Intel® Pentium® 4 Processor

Specification Update

August 2003

Document Number: 249199-040

Figure System Bus Reset and Configuration Timings

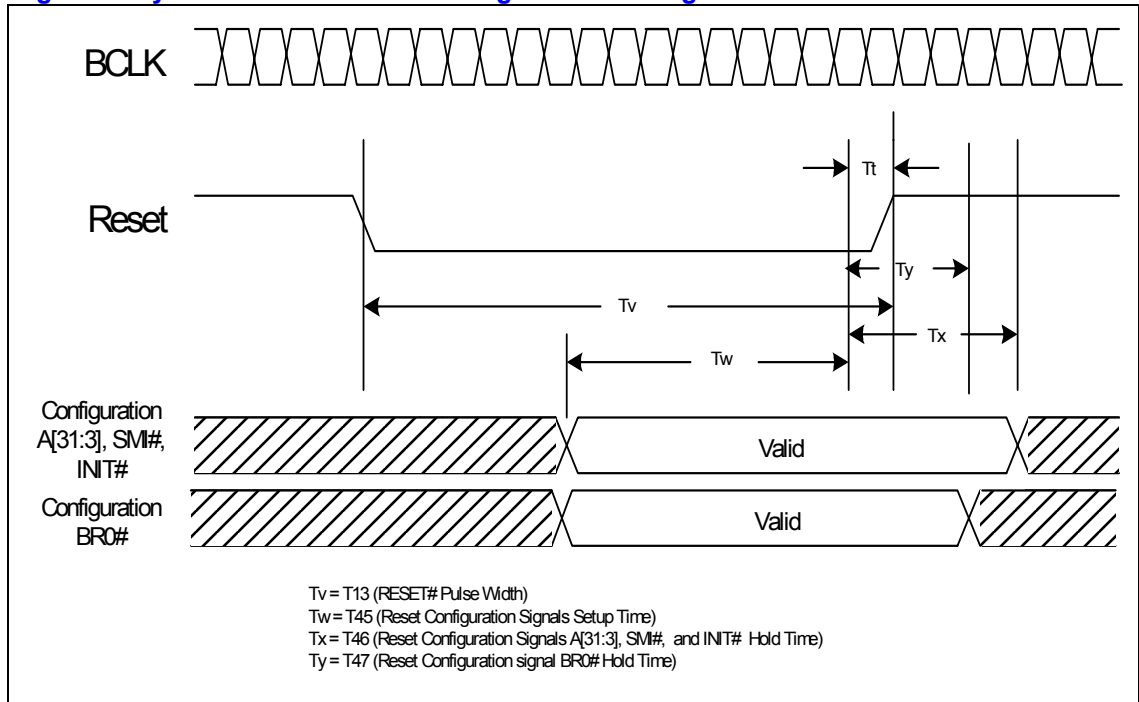
BR0# Maximum Hold Time Specification Change

The BR0# maximum hold time has changed to 2 BCLKs. This change will be shown in the “System Bus AC Specifications (Reset Conditions)” table and “System Bus Reset and Configuration Timings” figure of the Intel(R) Pentium(R) 4 Processor with 512KB L2 Cache on 0.13 Micron Process EMTS & Intel(R) Pentium(R) 4 Processor in the 478-pin Package Electrical, Mechanical, and Thermal Specifications (EMTS) & Intel(R) Pentium(R) 4 Processor in the 423-pin Package Electrical, Mechanical, and Thermal Specifications (EMTS). These changes will be incorporated in the next revision of the EMTS (Datasheet).

The following figure will be modified to reflect this change:

T# Parameter	Min	Max	Unit	Figure	Notes
T45: Reset Configuration Signals (A[31:3]#, BR0# INIT#, SMI#) Setup Time	4		BCLKs	12	1
T46: Reset Configuration Signals (A[31:3]#, INIT#, SMI#) Hold Time	2	20	BCLKs	12	2
T47: Reset Configuration Signal BR0# Hold Time	2	2	BCLKs	12	2

1. Before the deassertion of RESET#.
2. After clock that deasserts RESET#.
